Testimony of Jean Vissering

VISUAL IMPACT ASSESSMENT

ANTRIM WIND PROJECT (Docket No. 2011002)

July 30, 2012

1B

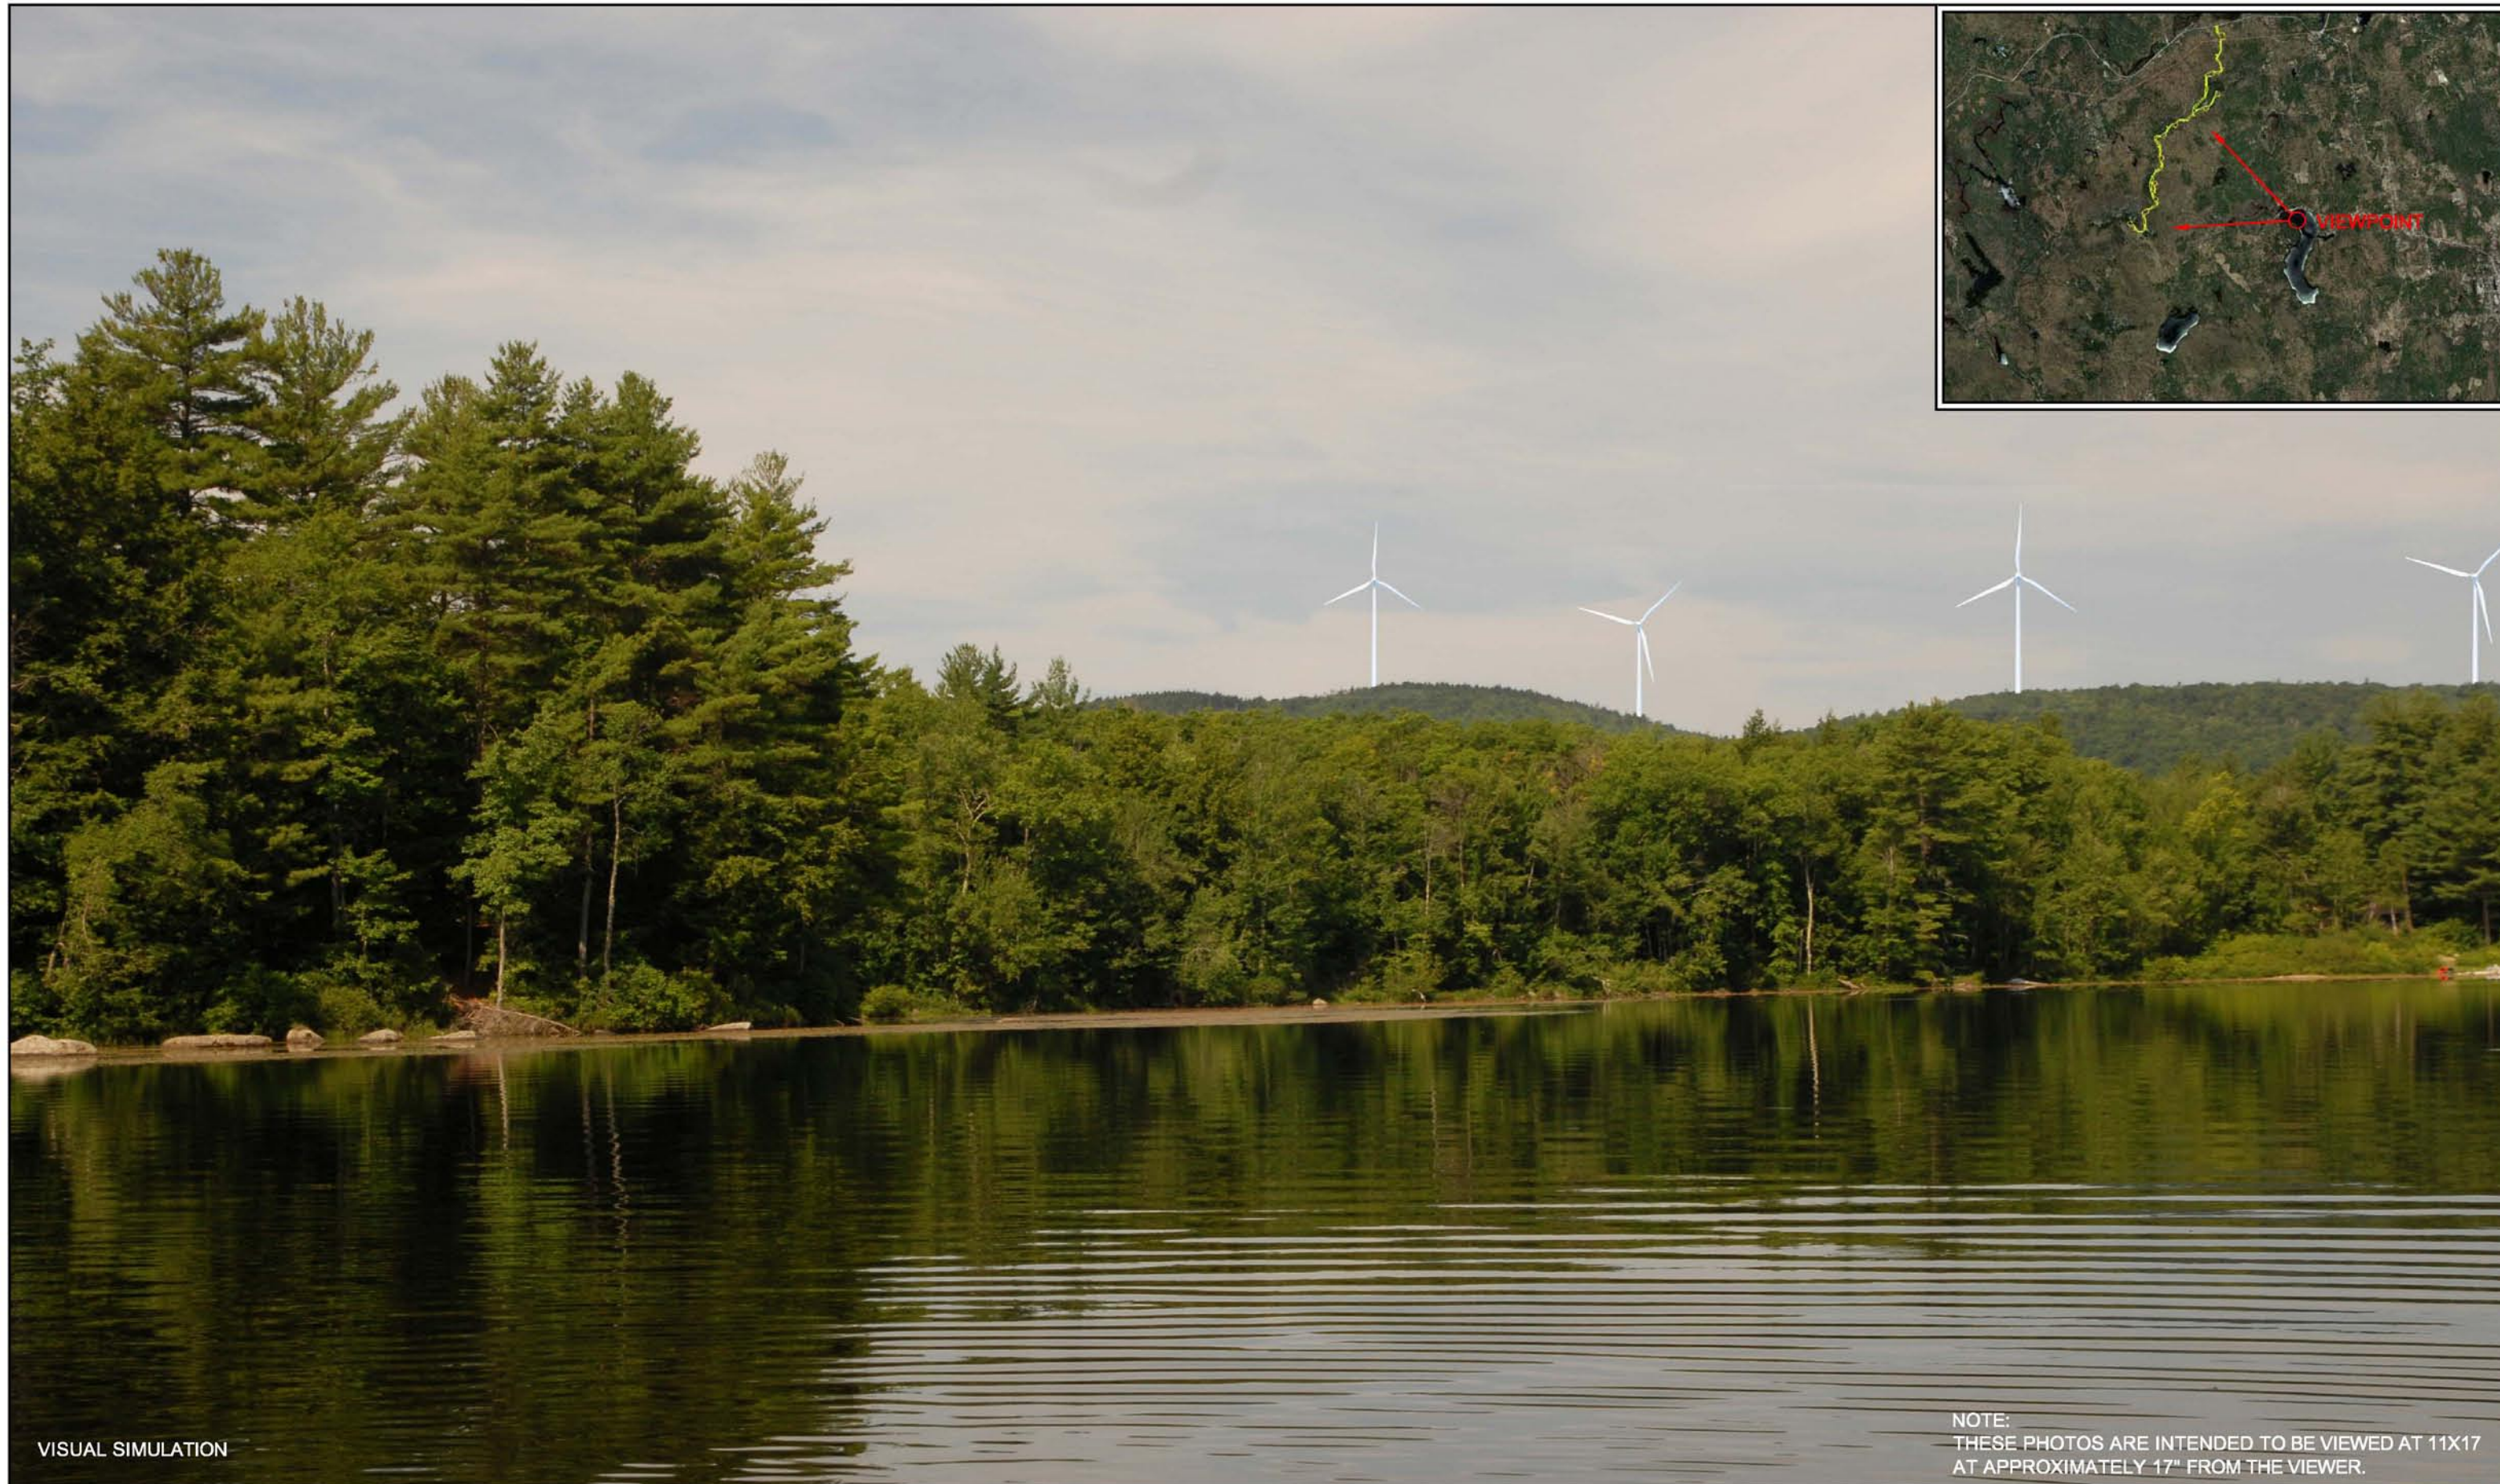
Nine turbines plus the meteorological tower are visible in the simulation provided by the applicant from the dam on Willard Pond. This area is a popular destination for walkers and swimmers. All ten turbines will be visible from various points around the pond, and most turbines will be visible from nearly all points on the pond. The turbines will be seen at relatively close proximity with distances ranging from 1.4 to 3.2 miles away. The impacts will be significant because of the existing condition which is entirely natural with no

development currently visible from the pond. Because this is a wildlife sanctuary and Audubon Preserve, there is an expectation that one will experience a natural setting that will be different from settings such as Gregg Lake. The pond is very scenic and one of the area's more popular destinations. (See Appendix A Simulation 1B)

- Eliminate turbines #9 and #10. These two turbines are the most prominent as viewed from Willard Pond, Bald Mountain and Goodhue Hill and will result in unreasonable adverse aesthetic impacts. Visibility of clearing around turbine #9 will also result in significant visual impacts.

3A

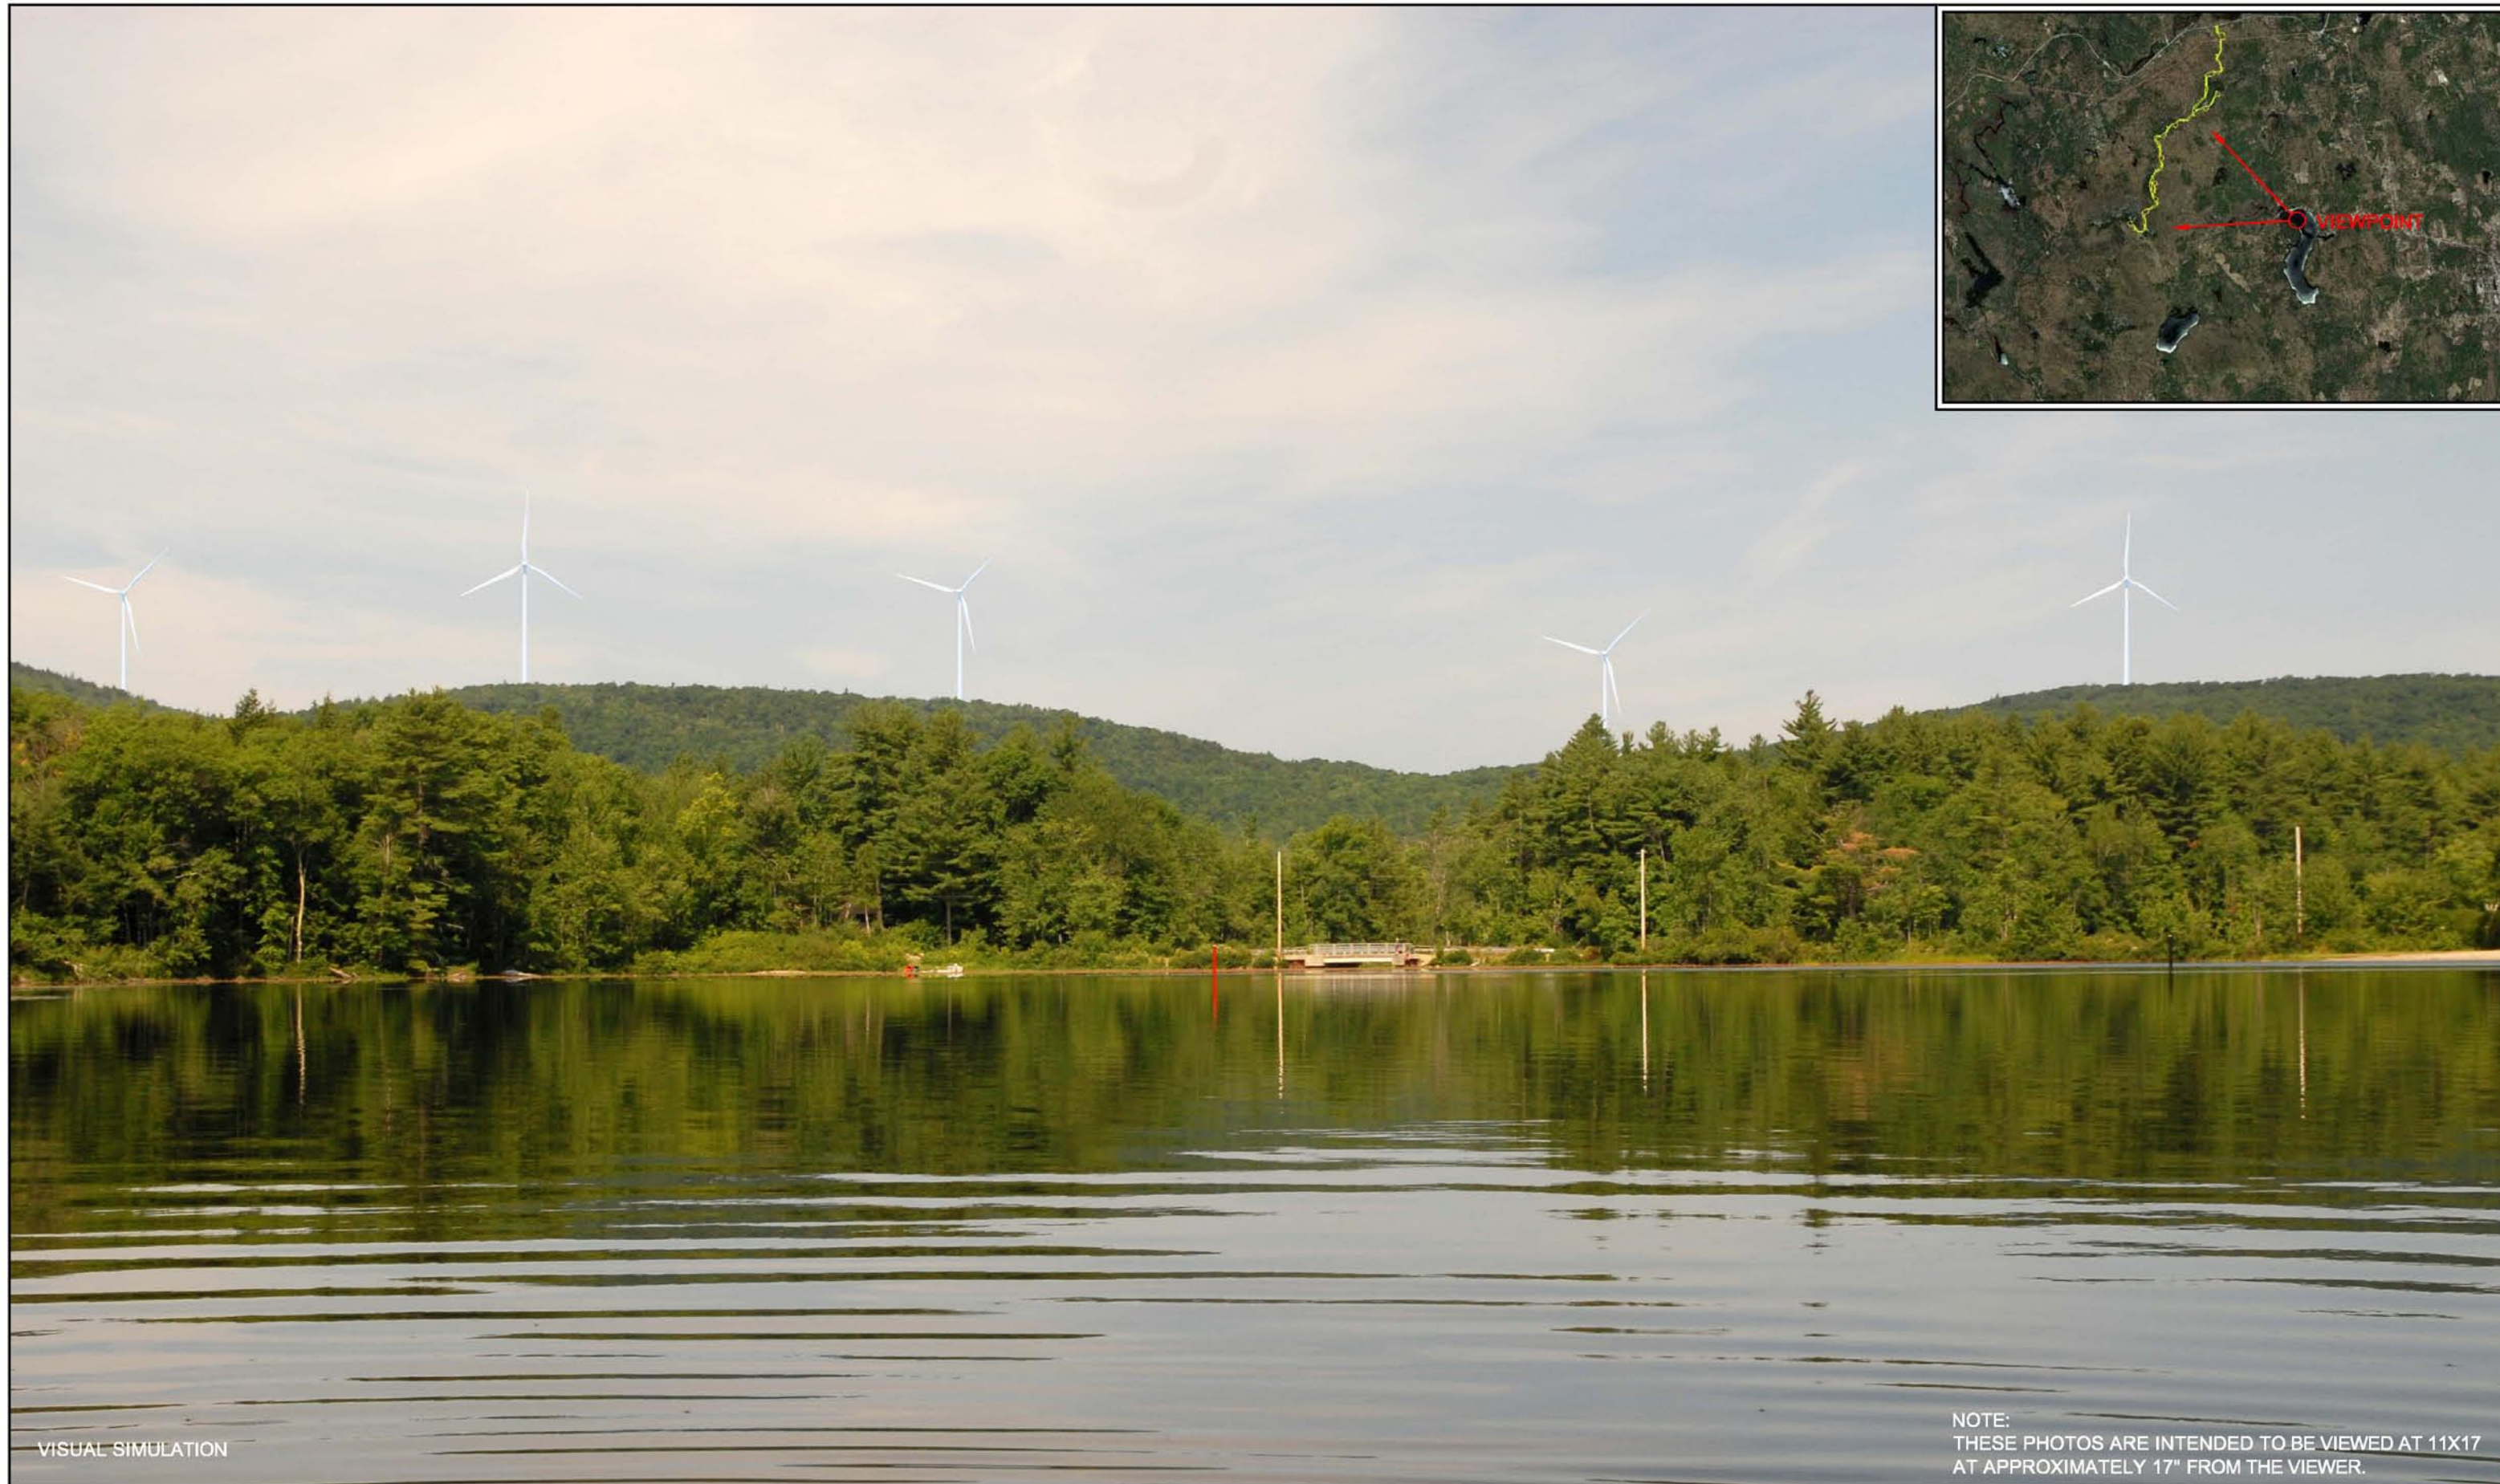
All 10 turbines as well as the met tower would be visible from various points on the lake and from the town beach/picnic area. They would also be seen in relatively close proximity with distances ranging from 1.8 miles to 2 miles away. The ridgeline is also fairly low in elevation ranging from 1,920 on Willard Mountain to 1,760 at the top of Tuttle Hill, and less on the lower portions of the ridge. Gregg Lake itself is at approximately 1040 feet above sea level. So the turbines at 492 feet in height will appear quite large in relation to the ridge itself. The beach is oriented away from the proposed project ridge and some foreground trees within this area will appear taller than the turbines moderating the apparent height and visibility of the turbines to some extent. Because the lake is developed and used by motorboats, there is not an expectation by users for an entirely natural setting as there is at Willard Pond. Nevertheless, the turbines will be a very dominant visual element from the vantage point of the picnic area, the lake itself and from portions of Gregg Lake Road.

- Use smaller turbines. The scale of the landscape in this part of New Hampshire is small with relatively low hills and mountains. The proposed turbines will overwhelm the ridgeline especially from a vantage point like Gregg Lake.
